**ASCE 41-17 Tier 1 Seismic Evaluation**

**DATE:** 5/18/2021  
**UC Campus:** UCLA  
**Building Name:** 6 Schoenberg – Herb Alpert Teaching/Organ Studio Building  
**CAAN ID:** 4335.3  
**Auxiliary Building ID:** 4335, 4335.1, 4335.2

**SUMMARY OF INFORMATION PROVIDED BY EVALUATOR:** **THORNTON TOMASETTI**

Seismic joint in wall at ground floor level (West side of building) in need of review and/or replacement cover.

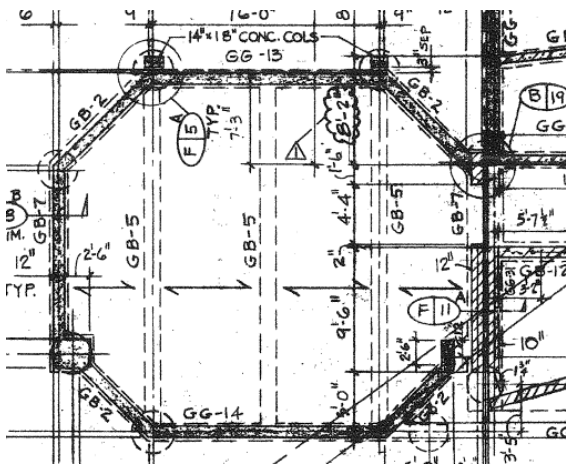
**6.1. Seismic Separation between Buildings:** During intense ground shaking by a seismic event the adjacent structures could collide causing localized damage. The damage would likely be limited to the cracking of mortar joints and joint separations, as well as tearing of the seismic joint cover over the top of the parapet walls. The vertical seismic joint cover on the west side of the building is starting to deteriorate and likely needs to be replaced to help prevent future rain water intrusion.

Roof Framing Plan

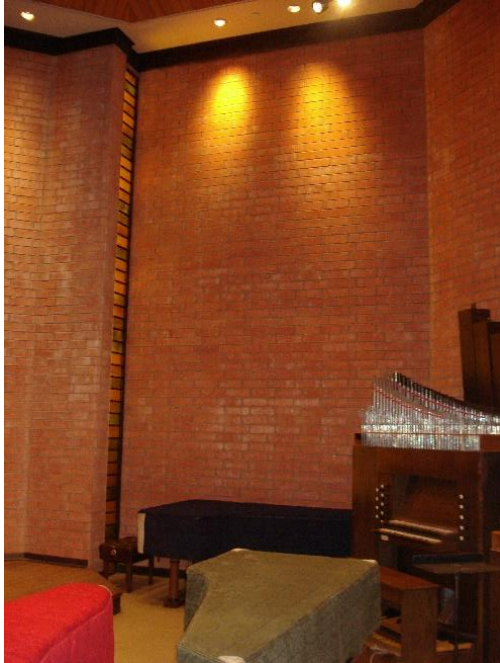
**Seismic Concern:** The brick wall reinforcing is #4 at 20" O.C. in each direction and the sum of the ratio of rebar in the vertical and horizontal planes is at least 0.002. The concern is the long vertical length of the windows in the organ room and possible breakage of the glass due to wall movement during an earthquake.

Organ Chamber Roof - some loose roofing at parapet

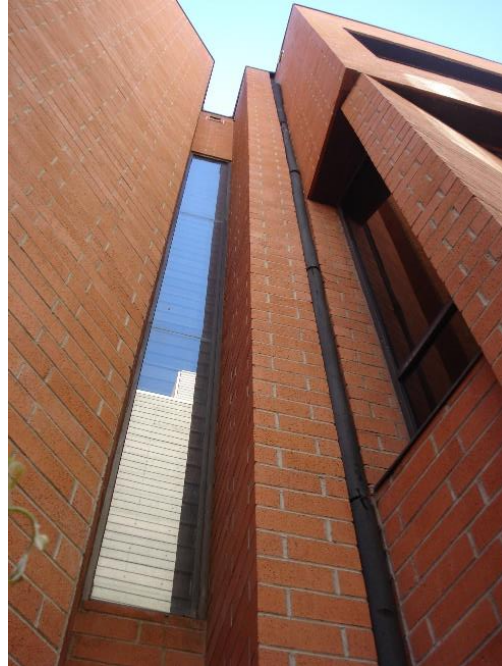
**DEFECTS AND DETERIORATION:** No structural defects or deterioration was noted while performing visual observations except at the roof where some roofing was falling away from the parapet walls.
